REVIEW OF THE DCPRA: LETTER REPORT-07/REV.1

A REVIEW OF SYSTEM ANALYSIS IN THE DCPRA:  
DIESEL GENERATOR AND DIESEL FUEL TRANSFER SYSTEMS

July 1989

Risk Evaluation Group  
Department of Nuclear Energy  
Brookhaven National Laboratory  
Upton, NY 11973

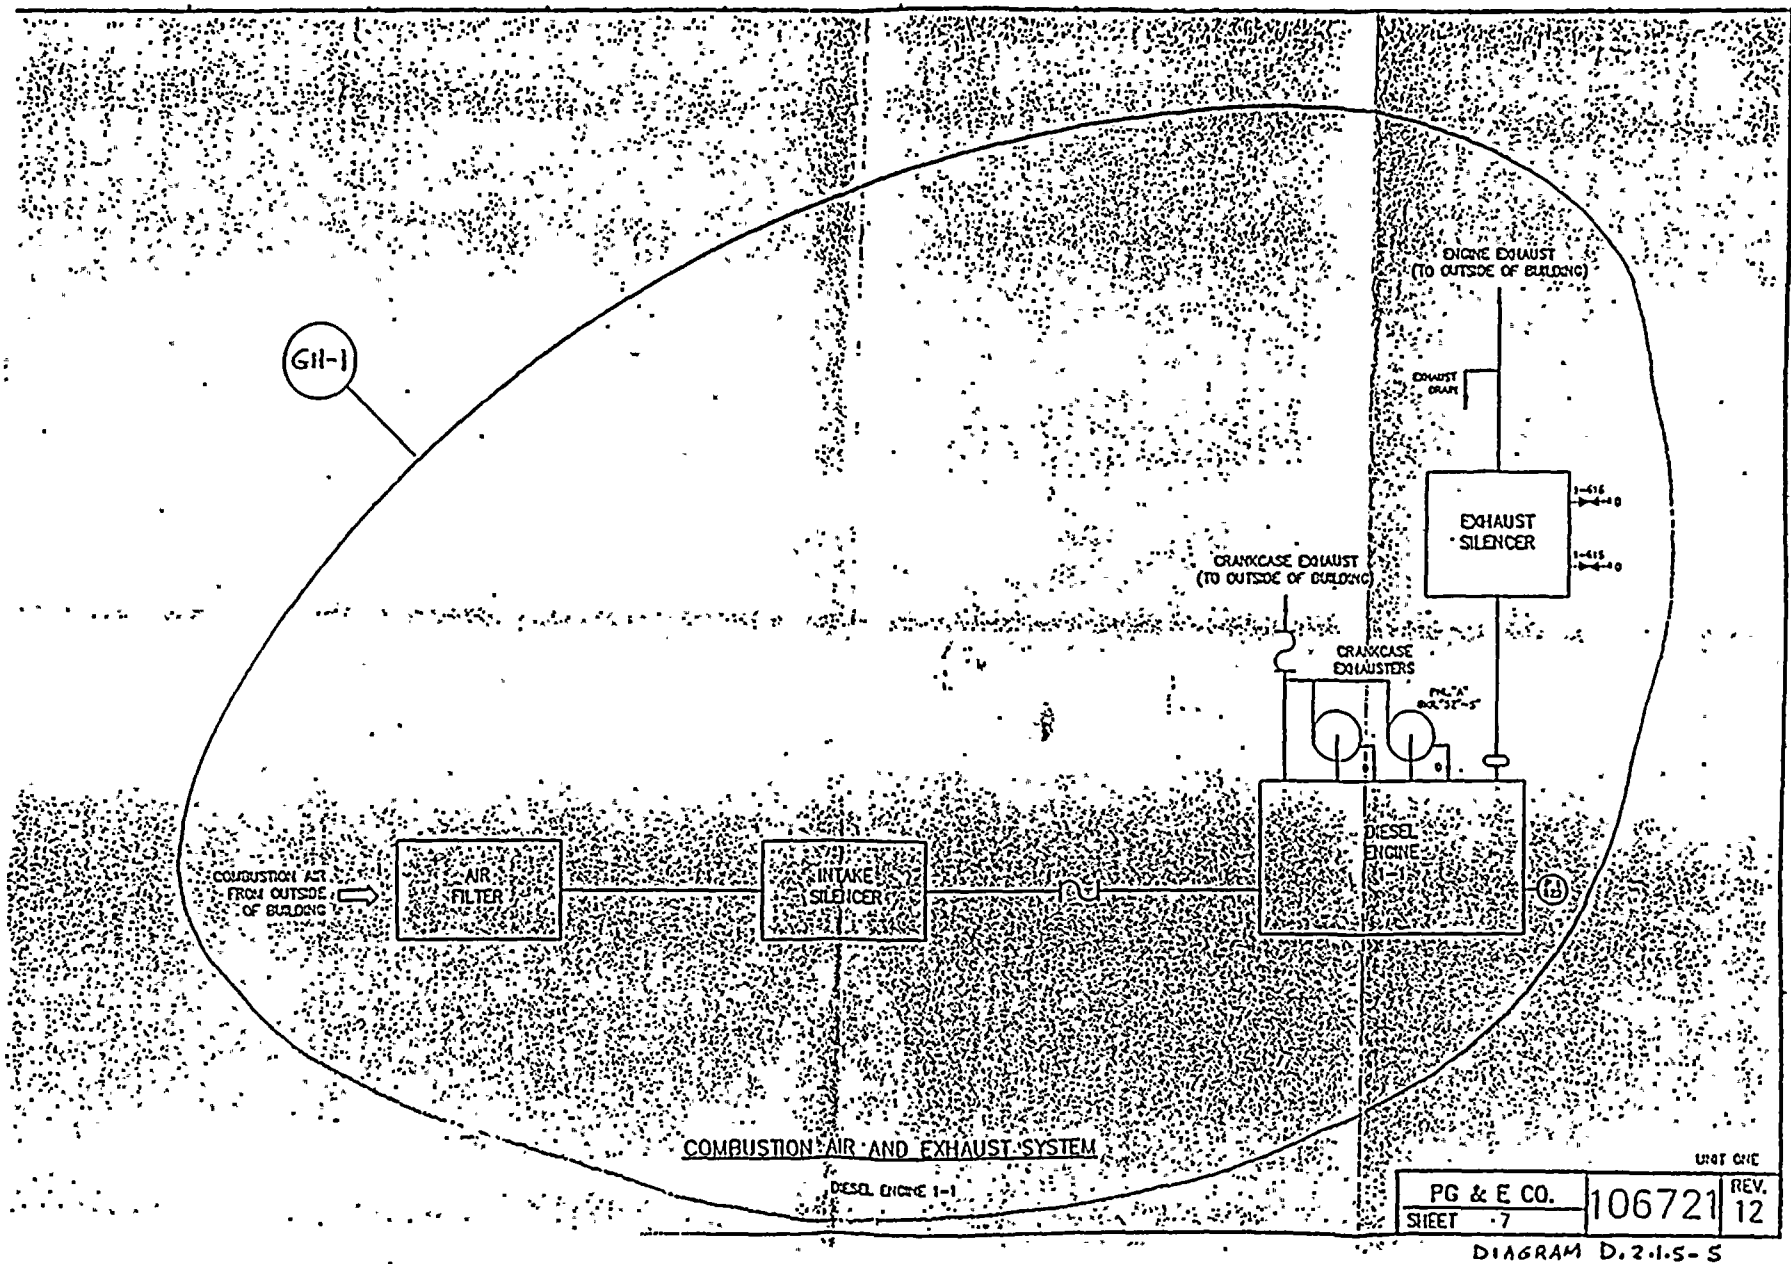
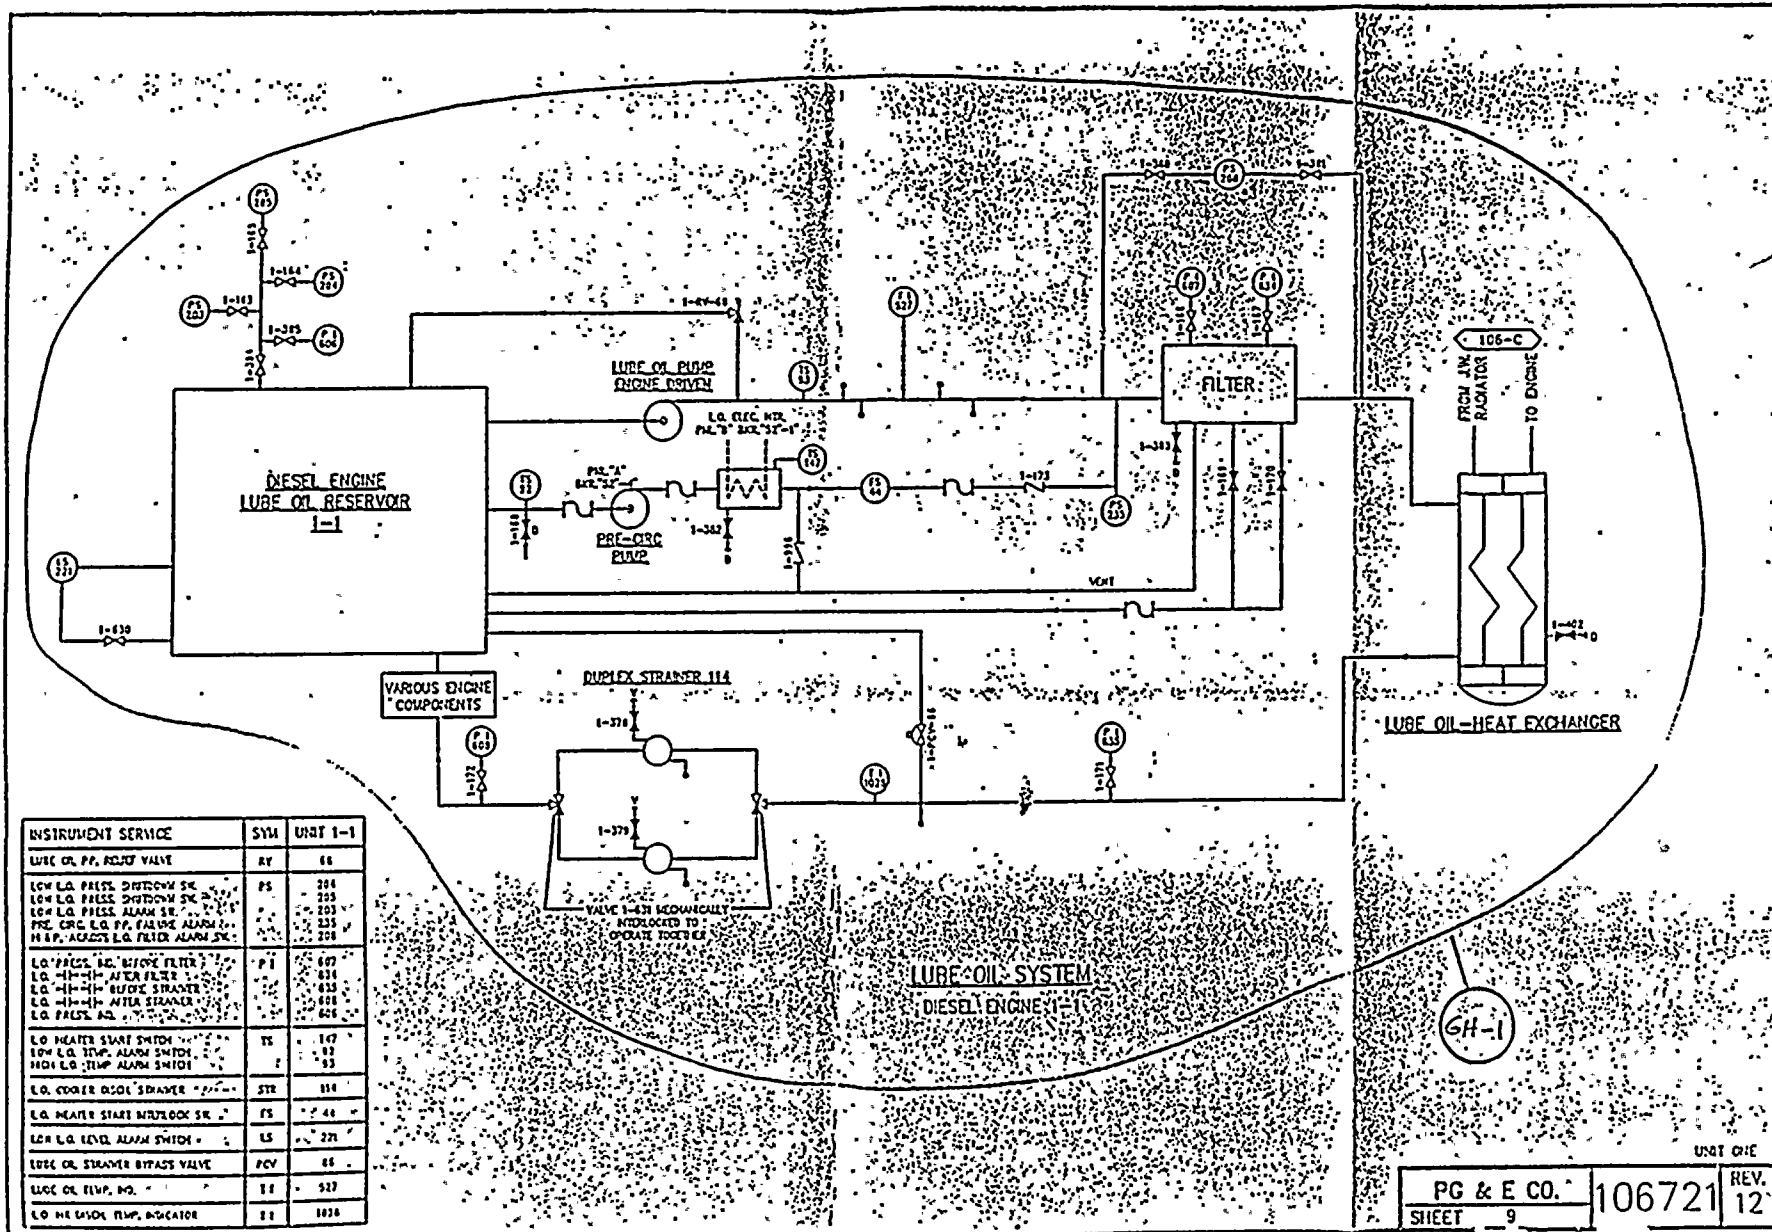
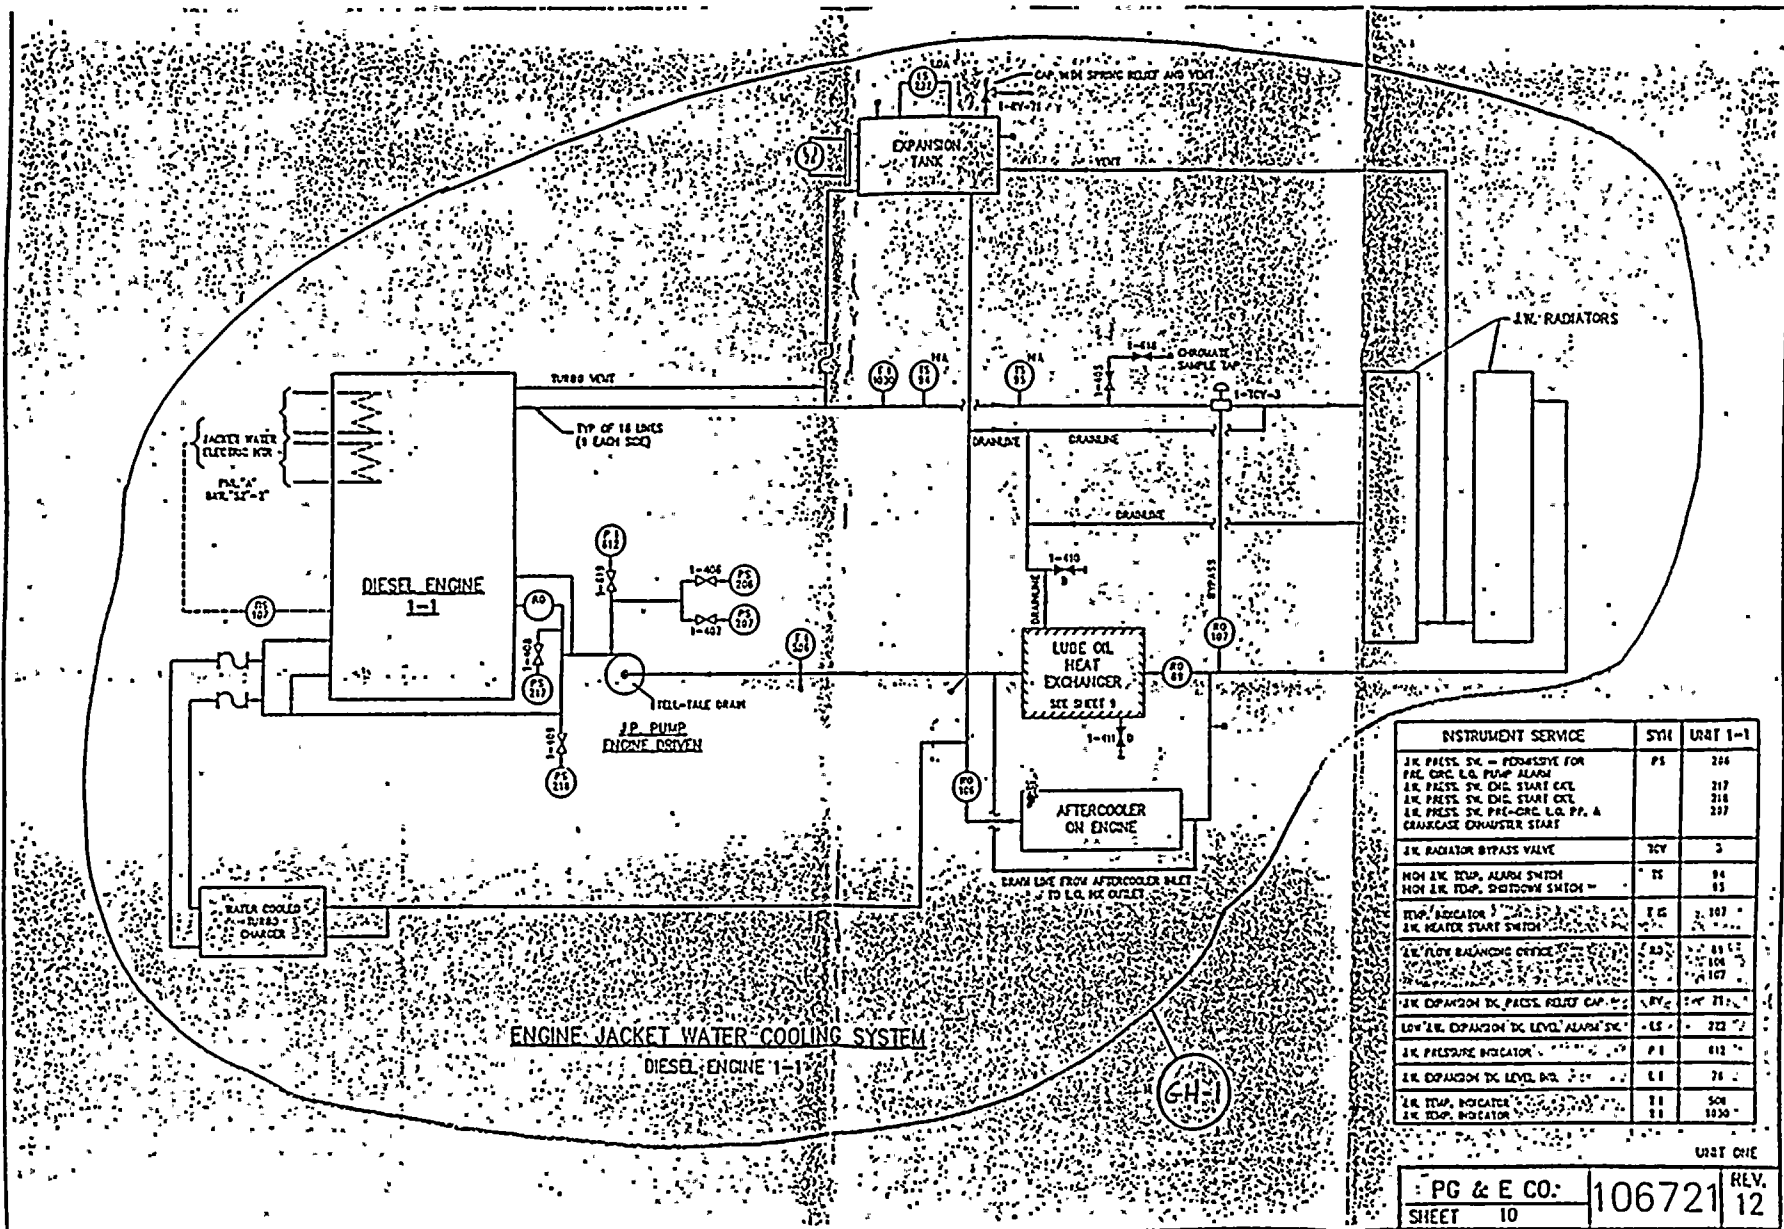
Another example: while the diesel supercomponent boundaries indicate several subsystems as part of the supercomponents (see Figures 2.6, 2.8, and 2.9), one cannot find any representative component failure rate contributing to the combined unavailability of those supercomponents. Such subsystems are: the cooling, the lubrication and the combustion air systems. Table 3.1 shows that the cooling system is the second largest contributor to the failure of the ALCO type diesels.
